DATE: April 5, 2012

SUBJECT: **Response to Bidders' Inquiries No. 5**
Wentworth Springs Road at Gerle Creek – Bridge Replacement
Project
Contract No. PW 11-30573, CIP No. 77118

Figure 3.6.1.8.1-1 California P15 truck

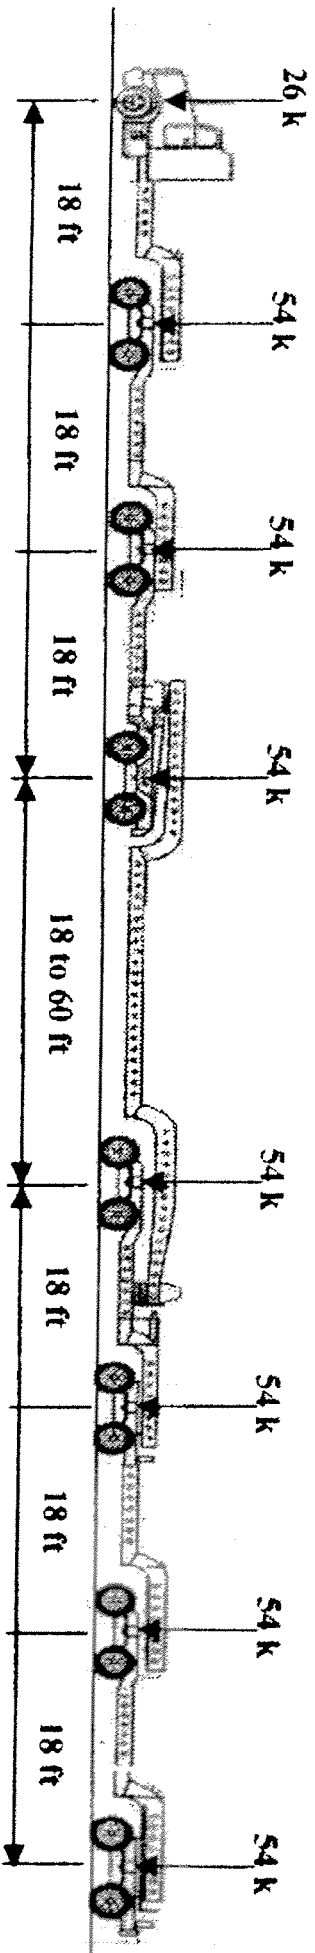
ITEM NO.	LOCATION, PAGE OR DRAWING NO.	QUESTION/ANSWER
5.01	General	<p>Question: Do you have a specification on the P-15 fire truck? I am looking for axle locations and weight distributions to each axle.</p> <p>Answer: See Figure 3.6.1.8.1-1 California P15 Truck from the California Amendments to AASHTO LRFD Bridge Design Specifications – Third Edition w/ Interims thru 2006 included as Attachment A to this Response to Bidders' Inquiries.</p>
